REVISION HISTORY			
REV	DATE	EFFECTV. BY	DESCRIPTION
6	10/15/2008	R.C.	TJP ADDED 72.0" SPRING CENTERS SEE 46125-R5 FOR PREVIOUS REVISIONS

Part Name: 5300# STRAIGHT SPRING AXLE 92.125" HUB FACE
 Material: 720 & 75.0" SPRING CENTERS w/ S/L SPINDLES
 Part No.: 46125 Page: 1 of 1 Rev.: 6

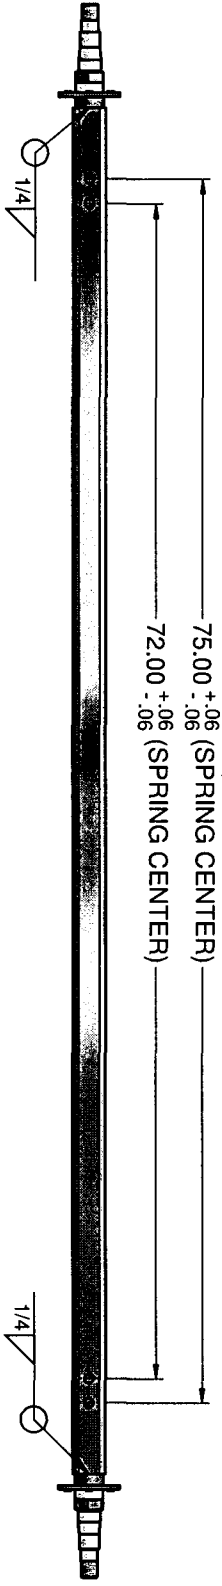
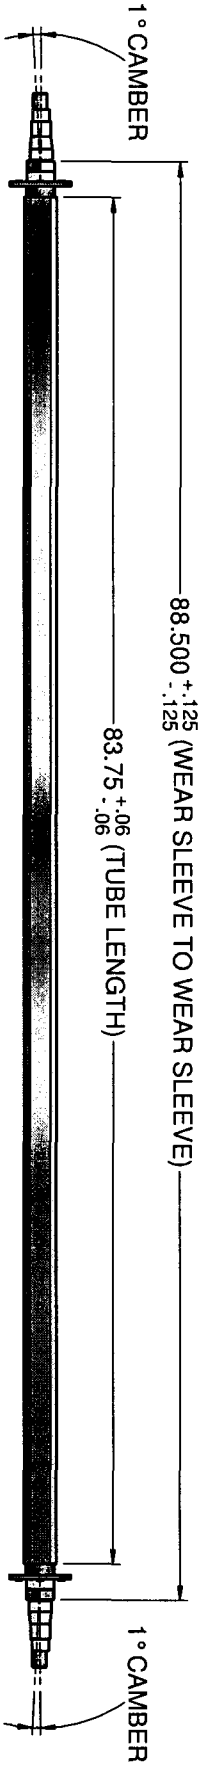
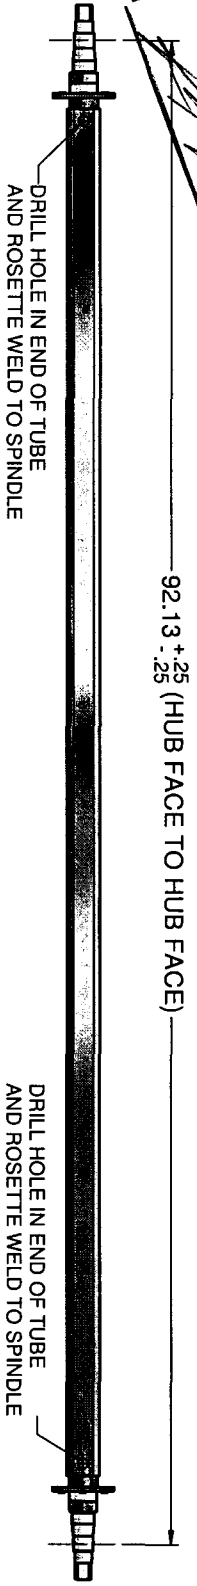
Camber Is 2.0 Degrees per Side
Approved
10/15/08

- 1) AXLE FINISH - GALVANIZED.
- 2) ~~1° CAMBER PER SIDE.~~
- 3) DRILL HOLES IN ENDS OF TUBE AND ROSETTE WELD SPINDLE TO TUBE.
